## DEVELOPMENT DETERMINATION PANEL MEETING

**ITEM 3.1**                                      **131 PACIFIC ROAD, PALM BEACH - MODIFICATION OF DEVELOPMENT CONSENT N0455/15 FOR DEMOLITION OF THE EXISTING DWELLING AND CONSTRUCTION OF A NEW DWELLING**

**SUBJECT: Section 96 Modification Application - N0455/15/S96/1 – S96 (2) Modification –****131 Pacific Road, Palm Beach NSW 2107****Modification of Development Consent N0455/15 – which approved demolition of the existing dwelling and construction of a new dwelling****Determination Level:** Development Determination Panel

Figure 1 - View from rear deck at 127 Pacific Road (photo taken by previous assessing officer as part of the assessment of the original development application N0455/15) Roofline connected by solid red lines, balustrade of upper floor balcony indicated by dashed red line.

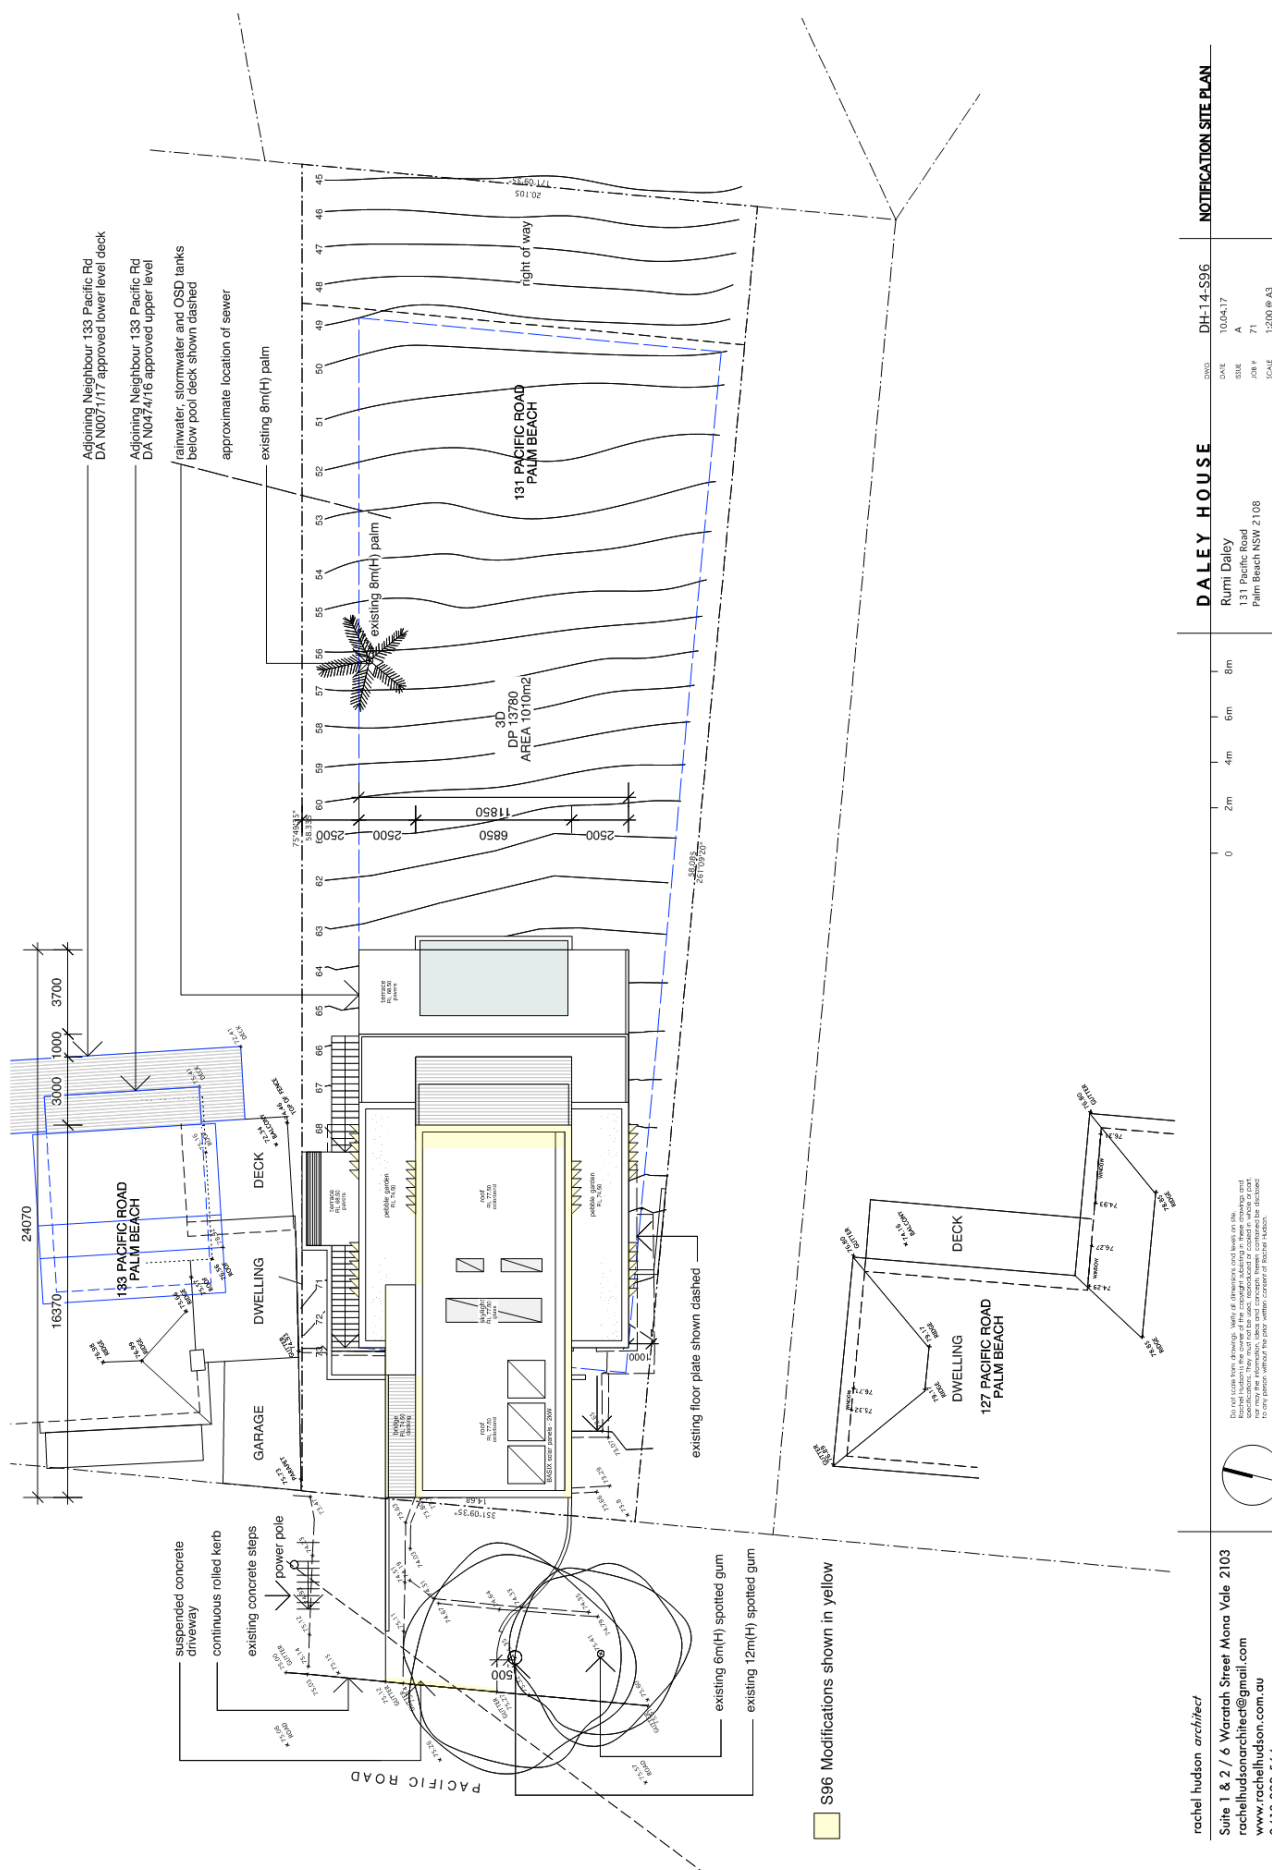
The subject S96 modification application is not consistent with many of the above conditions, resulting in a continuing impact as viewed from No. 127 Pacific Road.

No objection was received from No. 127 against the proposed S96 application, but this assessment is able to rely on Figure 1 as a reference point. Using Figure 1, the proposed modifications will continue to result in an impact to the existing views of the land and water interface at Palm Beach and Barrenjoey Headland. The views in question were described by the previous assessing officer as:

As the rear balcony fails to comply with previously mentioned conditions, the impact noted above by the previous assessing officer still stands and can only be addressed through the amendment of the plans in accordance with the conditions noted earlier in this assessment.

There appears to be no justifiable reason as to why the first floor cannot be amended in accordance with the conditions of consent under approval N0455/15. Therefore, it is recommended that the following condition be imposed:

*With the exception of the driveway realignment, retaining walls, window changes and privacy screens on the mid floor, this consent does not grant consent for those works to the first floor, which include changes to windows, reconfigurations to the master bedroom, ensuite, walk-in-robe, and garage.*

**NOTIFICATION ELEVATIONS 1**

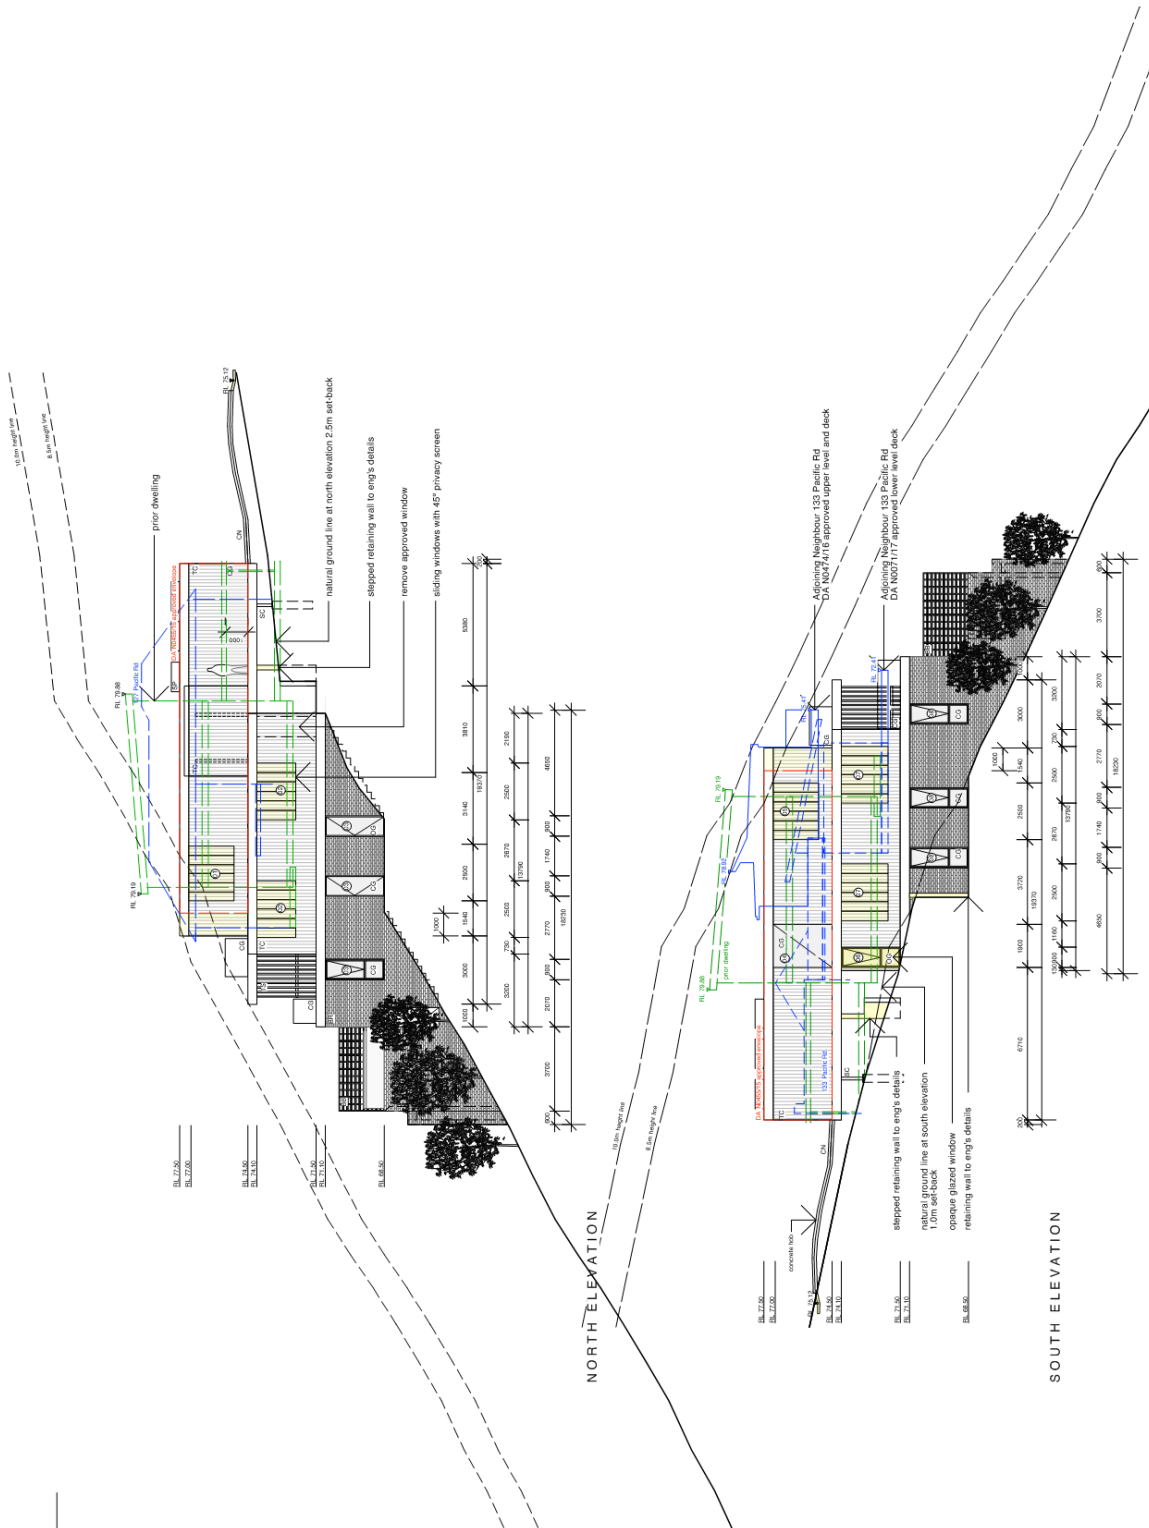
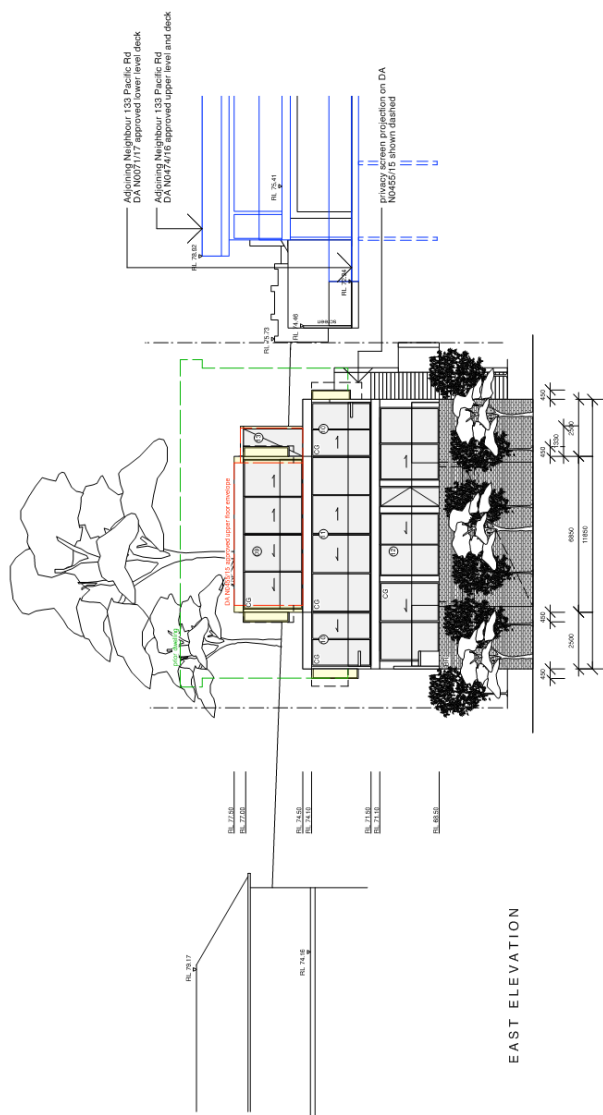
- a) The eastern end of the upper floor is to be setback a further 1.8m from the eastern boundary, such that the eastern external glazed wall of the master bedroom aligns with the red dashed line as shown on the approved Upper Floor Plan (DH-03-DA) referenced in this consent;
  - ☐ The eastern end of the upper floor has been setback 0.8m rather than 1.8m from the eastern boundary.

- b) The eastern eave of the upper floor roof shall not extend more than 600mm past the relocated eastern external glazed wall of the master bedroom;
- ☐ The proposed eave line remains approximately 950mm beyond the position it is to be relocated to as required by the above condition.

- ☐ Windows have been reintroduced along the northern and southern upper floor elevations.
- d) The eastern balustrade of the upper floor deck is to be situated at a maximum distance of 2.4m from the relocated eastern external glazed wall of the master bedroom;

- ☐ The eastern balustrade of the upper floor deck is still 0.5m beyond the position required under the above condition.
- e) With the exception of the upper floor deck with maximum dimensions of 2.4m x 6.0m, the remaining area of the mid floor roof is to be non-trafficable;

As well as the aforementioned conditions, the modification application seeks to modify the approval by widening the upper floor. Whilst acknowledging the widening is minor, the result creates further built form and a larger building envelope non-compliance, which this assessment does not support.

**B27. With the exception of works to driveway, this modified consent does not authorise any proposed changes to the upper floor.**
